MILITARY SPECIFICATION

SEMICONDUCTOR DEVICE, TRANSISTOR, NPN, SILICON, HIGH-FREQUENCY, POWER  
TYPES 2N3375, 2N3553, AND 2N4440  
JAN, JANTX, AND JANTXV

This amendment forms a part of MIL-S-19500/341B, dated  
29 March 1968, and is approved for use by all Depart-  
ments and Agencies of the Department of Defense.

FIGURE 7a. RF power gain ( $G_{pe}$ ) test procedure. "

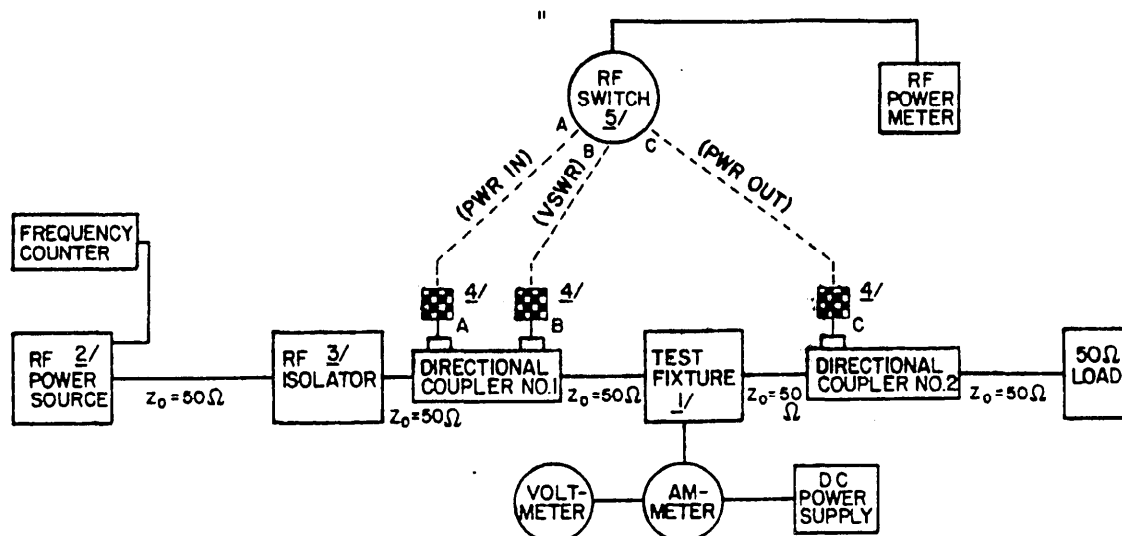
Add new figure 7a as follows:

- 1/ Test fixture is the circuit as described in appropriate figure 5, 6, or 7.
- 2/ RF power source may be any unit capable of generating desired power level at desired frequency with a harmonic and spurious content at least 20 dB below operating frequency level.

- 3/ The RF isolator may be any device (pad, circulator, etc.) capable of establishing at least 20 dB of isolation ( $RL \geq 20$  dB) between RF source and test fixture.

- 4/ Variable attenuators (or fixed if calibrated): Attenuator on directional coupler No. 2 shall be calibrated against known working standard either by means of calibration chart or suitable adjustment if variable. Attenuation at position "A" of directional coupler No. 1 shall be calibrated or adjusted so that actual power at test fixture is known. Attenuation at position "B" shall be adjusted to establish sensitivity needed to measure VSWR.

- 5/ RF switch may be eliminated if additional power meters are used.

1. Remove "test fixture" and install jumper between directional coupler No. 1 and directional coupler No. 2.
2. Set the RF switch to power output position "C".

3. Adjust frequency and power of RF source, as required by specification, and monitor frequency counter and RF power meter respectively (see note 4).
4. Set the RF switch to position "A" and adjust variable attenuator to obtain identical reading as power out in position "C" (see note 4).

5. Reconnect "test fixture" in test setup and insert device.
6. Adjust power supply to 28 Vdc.
7. Adjust circuit output tuning for maximum power gain and circuit input tuning for minimum VSWR. (Switch between power in, VSWR, and power out while tuning and repeat as many times as necessary to obtain minimum VSWR and maximum power out. Check power in level before taking final reading. Minimum VSWR is defined as minimum reading obtained on power meter with switch in position "B" and maintaining power in).
